ADDENDUM NO. 3 – May 18, 2026

**Missionary Minnie Lee Cotton Park Restroom
CIP PK 26-21**

This addendum amends the Contract Drawings and Specifications for this project as follows:

WALL SECTION - 1
 3/4" = 1'-0"

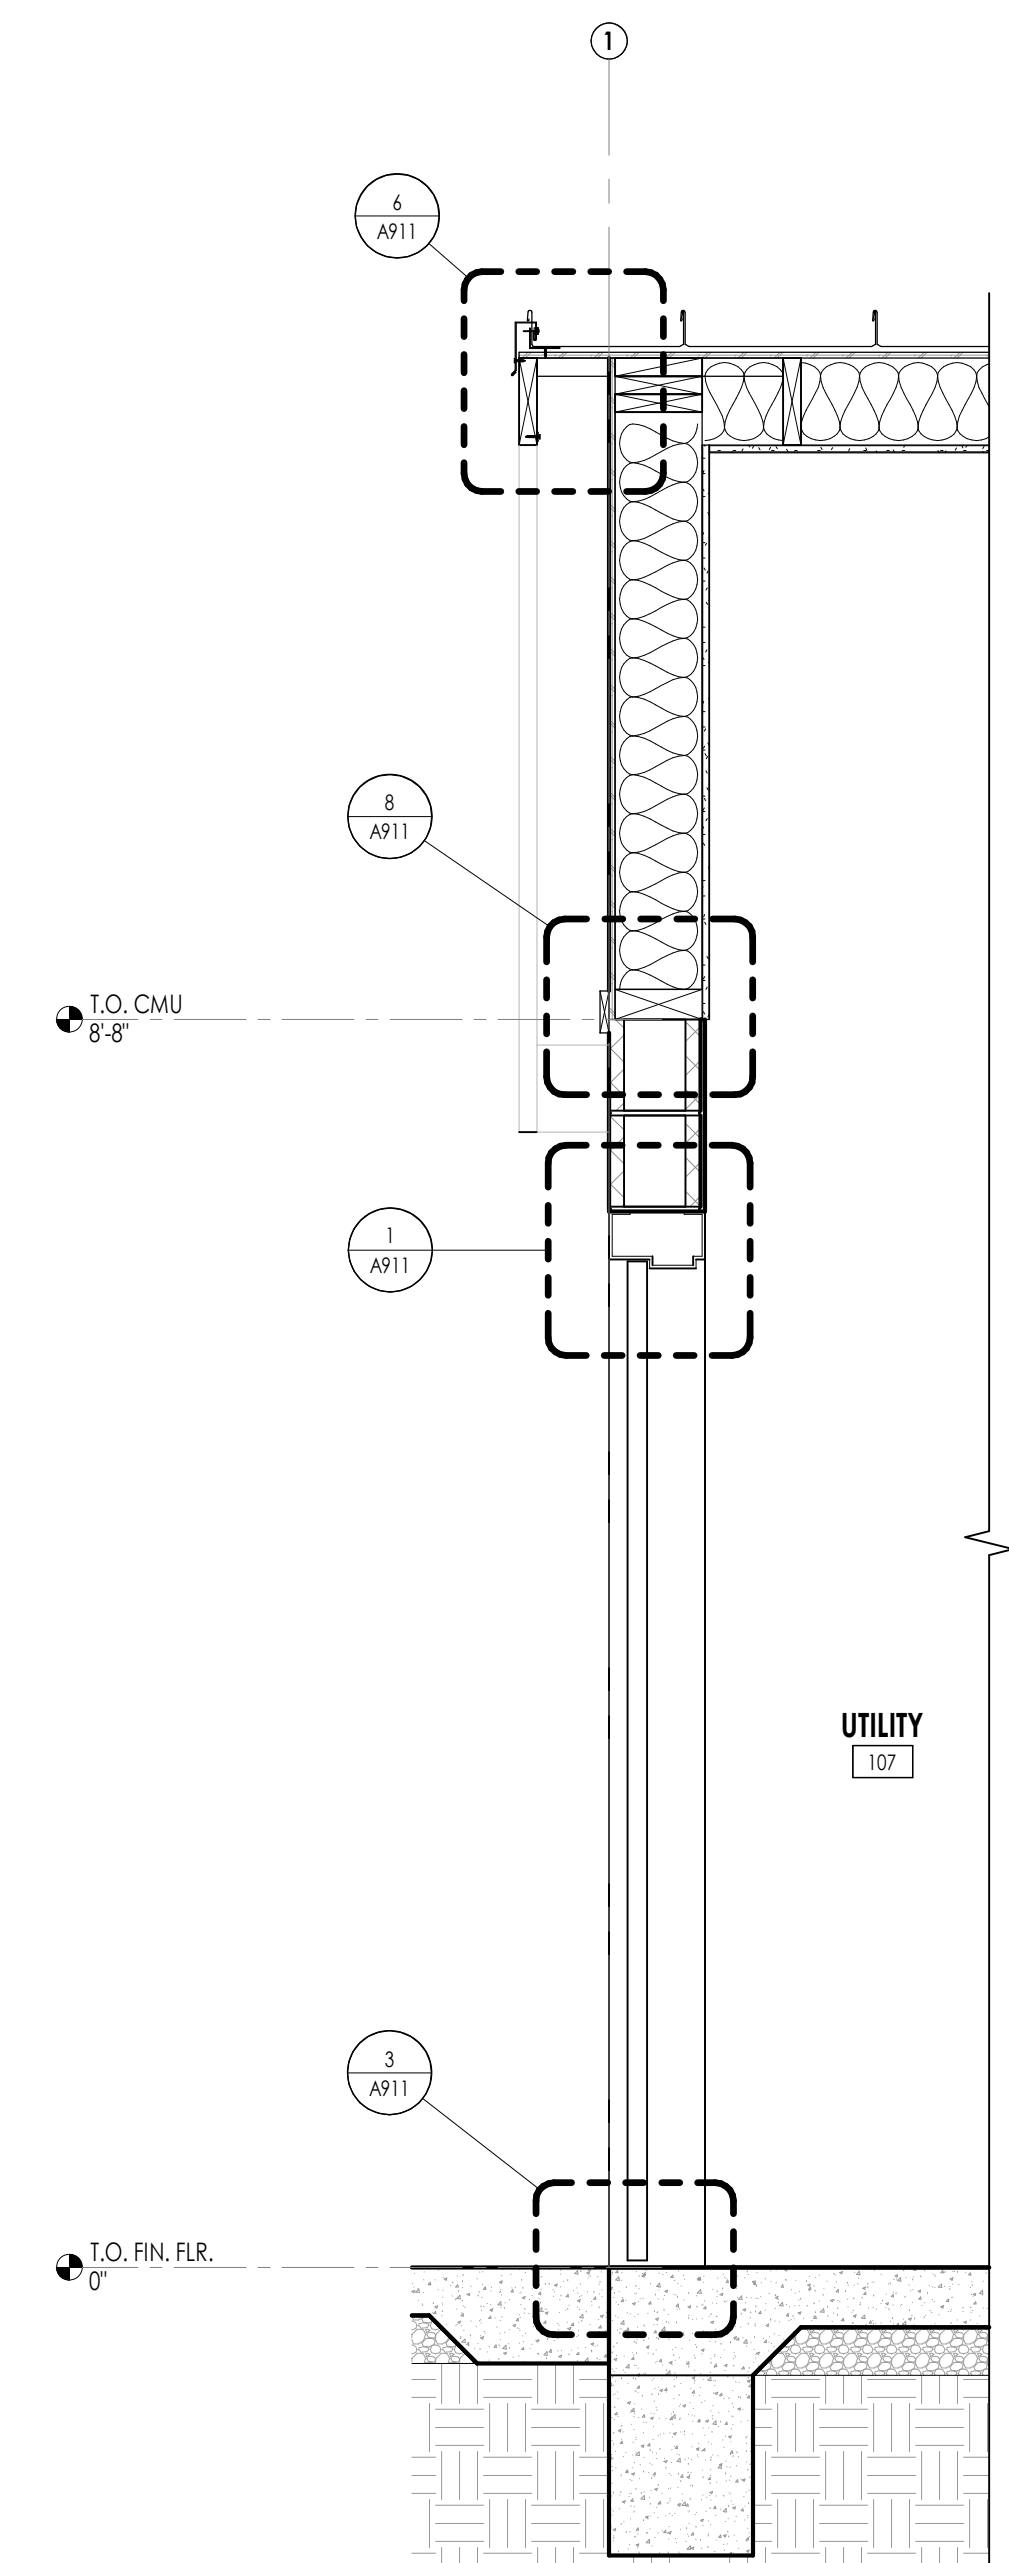
RFI 5: Key Note 3.7 is missing from Sheet A600, please provide.

A5: See attached revised sheet A600, tag 3.7 has been revised in the keynote schedule as 4.1 – see sheet A600, delta 3.

CMU 8"
 2 A910 1 1/2" = 1'-0"

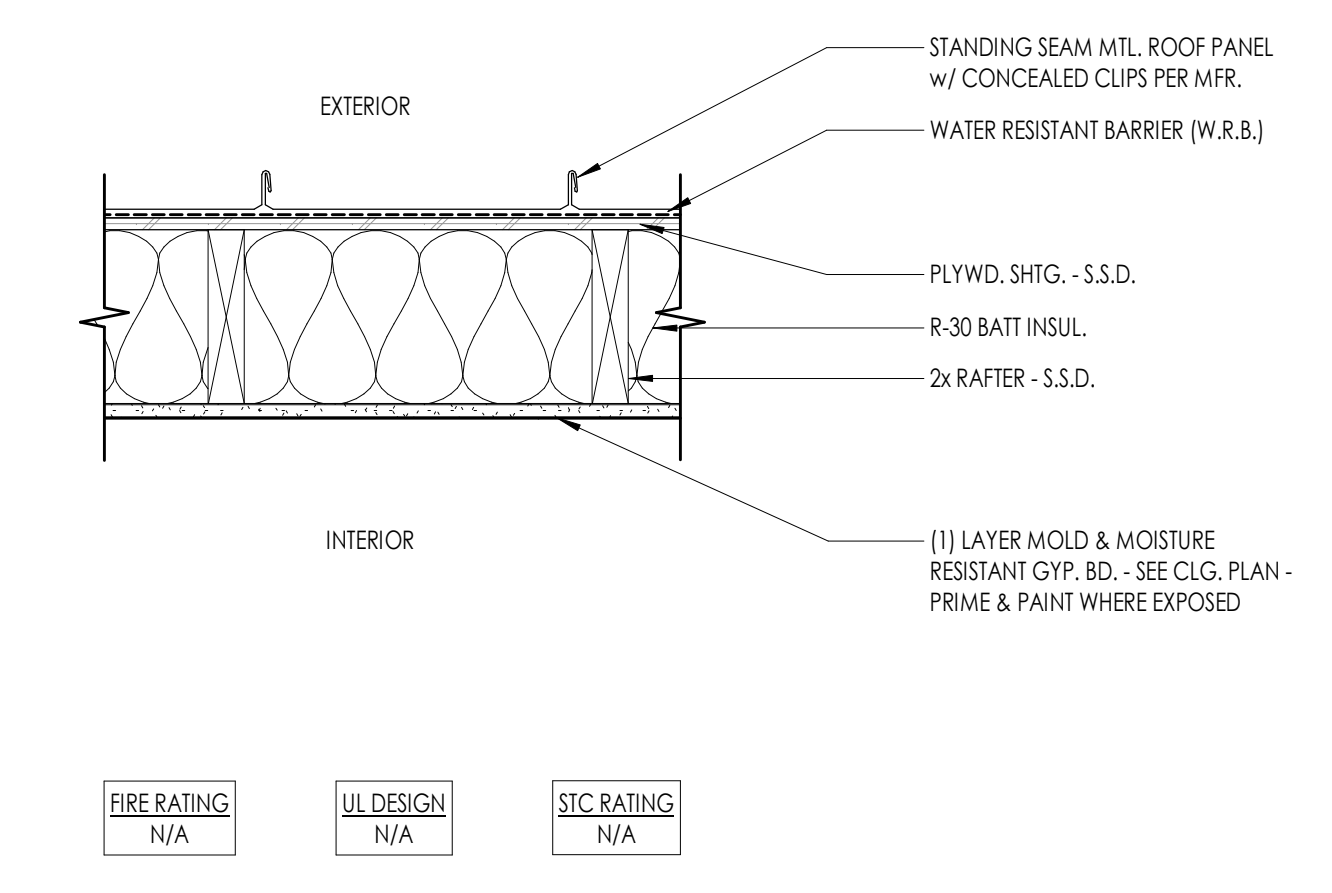
RFI 1: Detail 2 on Sheet A910 calls for 8x8x16 PRECISION-FACED CMU BLOCK, but details on Sheet A911 call for 8" GROUND FACE CMU - PRIME & PAINT, TYP. with PAINTABLE SEALANT -TYP. There is no masonry specification section included in the spec book. Can you clarify color and texture of the CMU block and if it is to be painted?

A1: Precision-faced CMU is the correct block type. Refer to the attached revised Sheets A910 and A911, where the discrepancy has been corrected. Prime with Sherwin Williams Loxon masonry primer or approved equal, paint with sealable paint followed by graffiti-resistant clear coating. Paint color to be determined by City Engineer following NTP.
